# **Hornsea Project Four**

## **Net Zero Teesside Development Consent Order**

### **Comments on the Applicant's Submissions at Deadline 2**

**Deadline: 3, Date: 23 June 2022**

**Figure 4.12 Cross-section through the Regional Structural Framework Model**

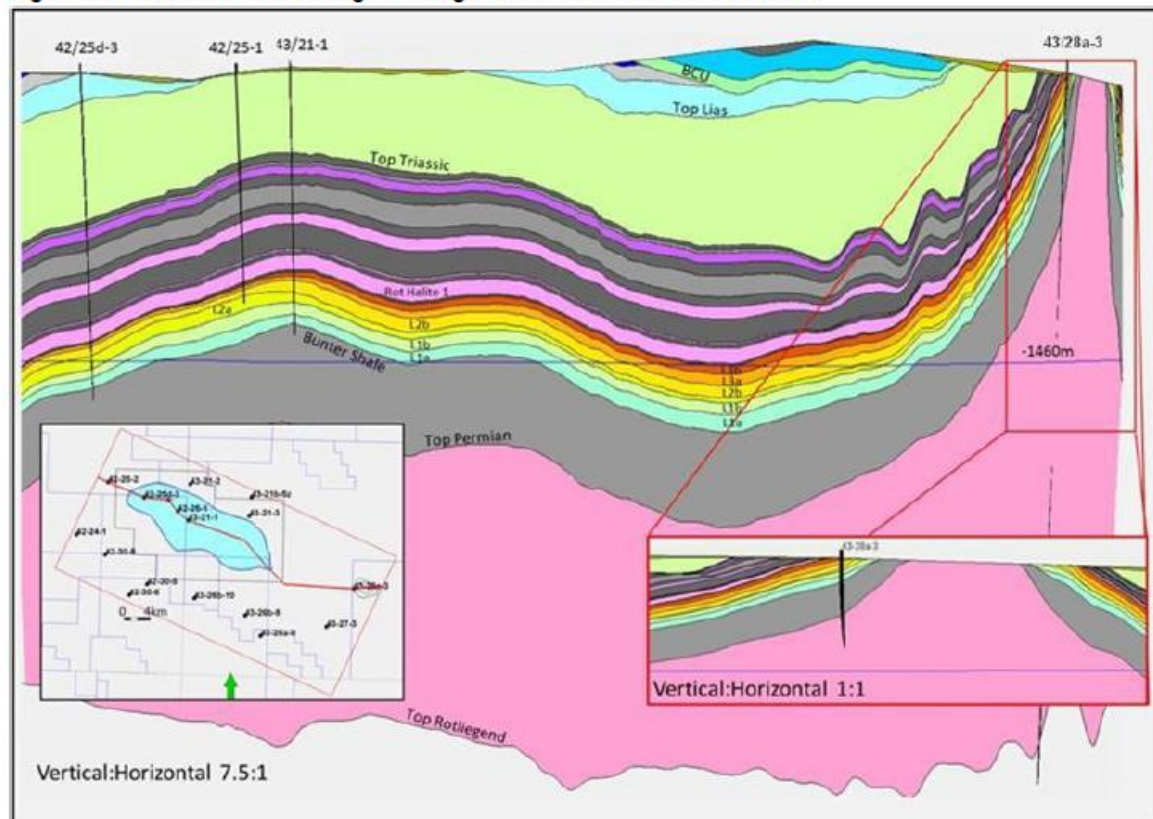
below the seabed. Between the top Bunter and the seabed there are multiple potential sealing zones starting with the Rot clay and halite directly on top of the Bunter, but also including several other halite, anhydrite and clay zones up to the top Triassic at about 500m TVDSS at the shallowest point, see the figure below from K42 White Rose report [19].

There are some faults interpreted in the overburden but these are not likely to be open through the halite and anhydrite zones. Sutherland et al [27] describe it thus ".... *only minor faulting is observed in the overburden above the storage area .... The possibility of seal failure along these faults is not deemed to be a risk as the overburden faults appear to sole out in the overlying Rot Halite, and there is an approximately 1 km thick section of sealing stratigraphy. This has been confirmed by geomechanical modeling.*" And "Geologic leakage (through open faults/fractures or induced faults/fractures) from a fully evaluated and characterized store with a proven seal is extremely unlikely if injection pressures are adhered to." The high quality sealing formations are one of the reasons why the Endurance structure was chosen as a CCS site. According to bp's answer to Q9, even a sparse OBN survey should be able to image from the upper Triassic (500m TVDSS) down to the reservoir. If there was to be a leak of CO<sub>2</sub> to the seabed through the overburden (as opposed to through wells which are not sealed properly) it would take many years and the CO<sub>2</sub> would likely have to pond at various intermediate depths before breaking into the Lias. In other words, OBN 4D monitor surveys should pick up any CO<sub>2</sub> escape through the Rot seals long before the CO<sub>2</sub> reached the top Triassic. In addition if there was a baseline survey acquired with good imaging of the near surface (<500m below seabed) before the wind farm is in place, then a repeat survey using a short streamer system such as P-cable could be run quickly after any CO<sub>2</sub> detection at the seabed, just in the area around that detection point, and provide an ability to see how the CO<sub>2</sub> has risen up through the shallow overburden.

Figure 25: Detectability of CO<sub>2</sub> in thin beds. The seismic response is shown in tracks '4D Nrs and 4D Frs' (Nears = 10° and Fars = 30°). Standard resolution only detects part highlighted in green and misses the additional CO<sub>2</sub> shown in pink, which is detected at high resolution.

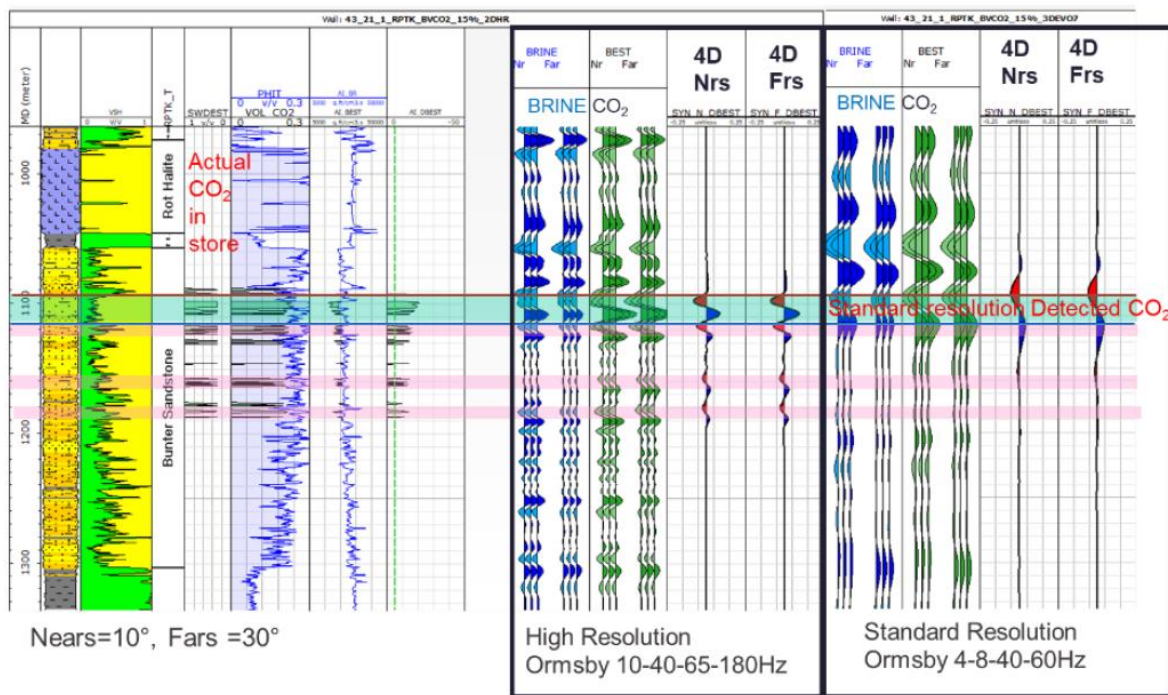
Section 7.3.1 on pages 44 – 46 outlines the requirements for 4D seismic data in relation to the highly stratified Bunter sandstone. "To simulate CO<sub>2</sub> in high porosity/permeability in thin beds a fluid substitution was carried out with a porosity cut off at 28%" as shown in figure 25 in bp's report, reproduced below and in Sutherland et al [27]. bp goes on to say "whilst any standard resolution seismic will detect thicker layers of CO<sub>2</sub>, the thinner layers only show a 4D response .... at high resolution". This describes standard resolution vs high resolution in terms of temporal frequencies. But the issue under discussion is the spatial sampling of OBN compared to streamer. In this report bp is only showing how spatial sampling affects temporal bandwidth for 2D high resolution (2DHR) towed streamer compared to 3D conventional towed streamer. There is no reason to assume that OBN data would have the same bandwidth as the 2013 conventional 3D streamer data, as implied by bp. Sutherland et al [27] gives more details on the fluid substitution modelling and how the bandpass filters were derived from analysis of 2D high resolution test lines acquired over Endurance in 2020. I propose that this work should be expanded to include synthetic seismic datasets from different survey designs (OBN and others) for comparison.

Figure 26: Example of high resolution towed streamer data over Endurance

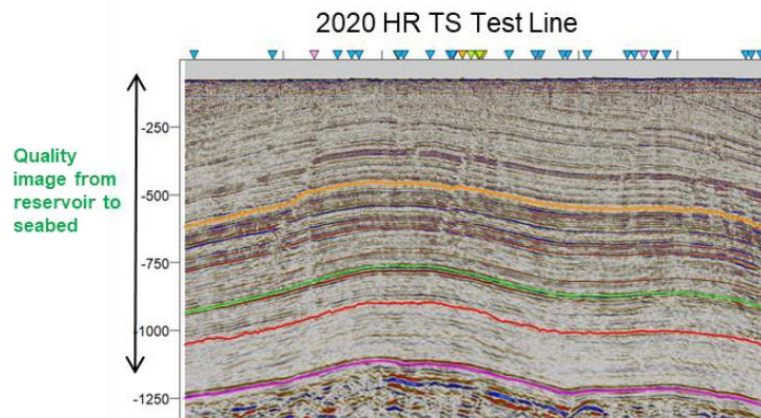
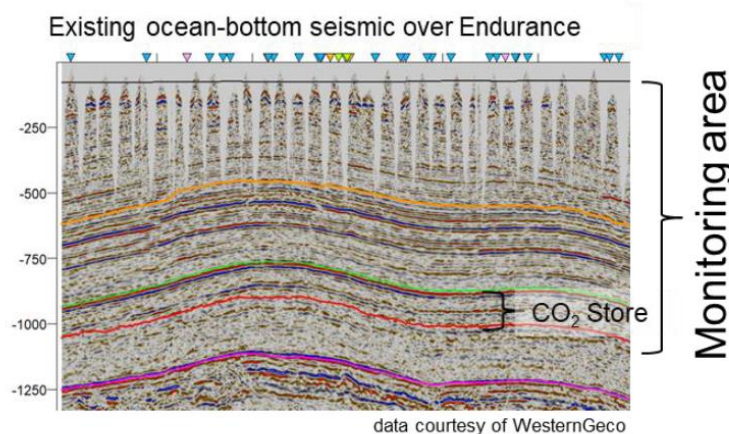
bp then goes on to compare one of the 2020 high resolution 2D test lines with a 1997 sparse 3D OBC line in an attempt to demonstrate the differences in data quality between different data acquisition methods. This is shown in figures 26 and 27 which are reproduced below. As can be seen, the sparse line OBC data does not have good coverage in shallow section and has lower signal-to-noise ratio at the Bunter level. This is not a like for like comparison and therefore not a fair representation of OBN vs towed streamer for the issues under discussion.

Figure 30: Modelled near offsets with wind turbine exclusion zones

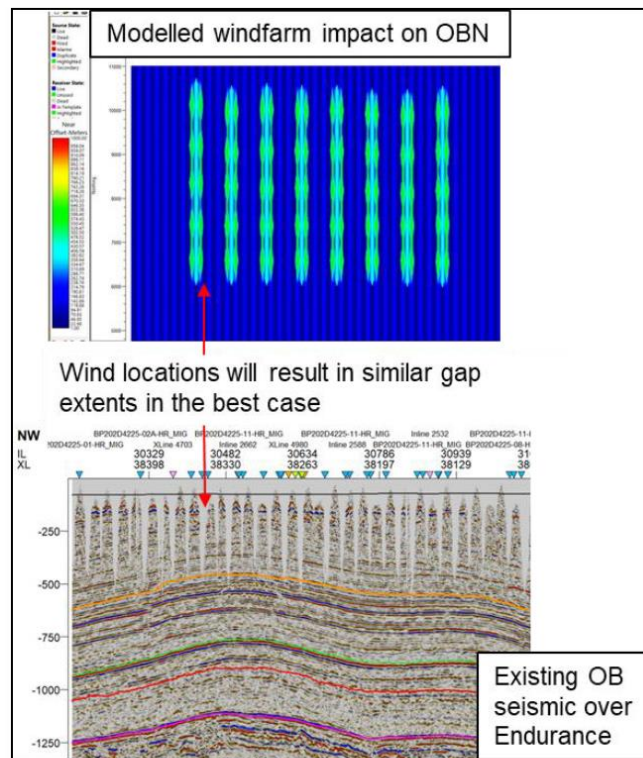
The figure above is shown on slide 9 and also appears in bp’s technical assessment [5] as Figure 30. It appears to show the nearest offset in each subsurface bin. It is not explained how this map was created but the vertical stripes would imply that sources were acquired in one azimuth only. It would be useful for bp to explain this map in more detail and whether maps from other possible acquisition templates were created for comparison.

On page 49, bp compares the option of a sparse vs dense OBN survey over Endurance. However it does not define the parameter range assumed for "sparse" or "dense" OBN. How did bp generate the "modelled windfarm impact" in Figure 30 of its report (reproduced below)? What assumptions were made on source and receiver spacing? In reality, there is a continuum between "sparse" and "dense". There is no reason to think that OBN will not produce good 4D results, given that it usually gives high quality 3D results when used in the oil and gas industry [18].

OBN can provide a technically sound method of acquiring 4D seismic data for CO<sub>2</sub> monitoring at the Endurance site, particularly if backed up by the use of something like P-Cable for investigating the very near surface in specific areas of concern. According to bp's answer to question 9 in the Q&A document [8] which followed the OBN workshop in October 2021, even a fairly sparse OBN survey with a conservative approach to positioning nodes near wind turbines would be able to image from the upper Triassic (500m TVDSS) down to the reservoir. A denser OBN design with nodes placed 50m and source points 100m from turbines can reasonably be expected to do much better, and should be modelled. The OBN 4D data would then be able to monitor the spread of the CO<sub>2</sub> plume in the reservoir, and also detect if any CO<sub>2</sub> has breached the primary seals (Rot clay and Rot halite). Repeat P-cable surveys could be run quickly after any indication of seal breach, or if CO<sub>2</sub> is detected at the seabed with non-seismic monitoring methods, and provide an ability to see if and how the CO<sub>2</sub> has risen up through the shallowest part of the overburden (sea bed to 200m TVDSS).

Figure 34: Example of variation in current direction and strength in the area (yellow box) over a 24-hour period (22/09/21)

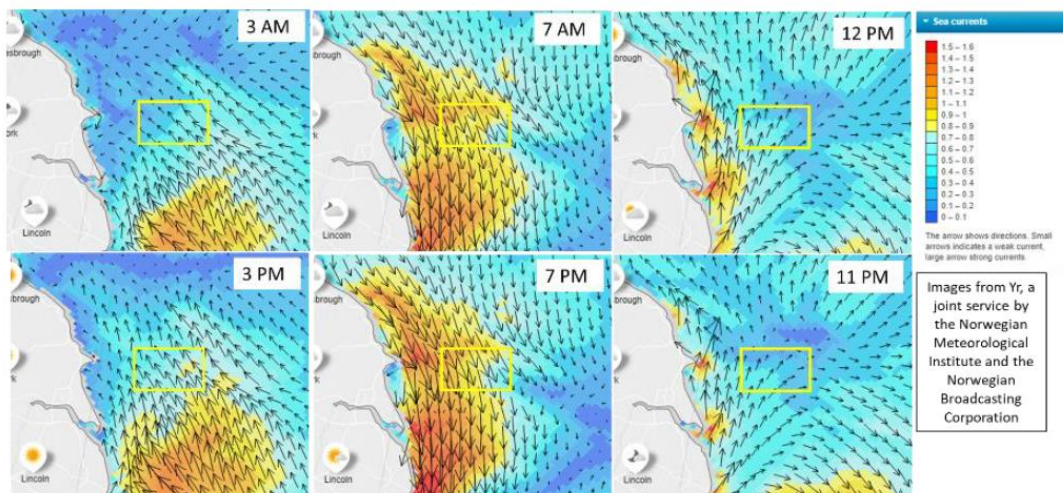
Section 7.3.3 and Figure 34 (reproduced below) describe the challenges related to strong currents in the Endurance area. bp states *"Acquisition in the area around Endurance is complicated by the strong tidal currents. The maps below illustrate the change of direction of the dominant current every 12 hours. This will make sailing the seismic source boat along specific lines inside the windfarm difficult. We anticipate that at least 25% extra time will be required for weather restrictions and difficulty in achieving matched source-receiver pairs for accurate 4D differencing."* Data acquisition problems related to strong tides are going to be worse for streamers compared to OBN when it comes to matching source-receiver pairs between survey, whether or not there is a wind farm in place.
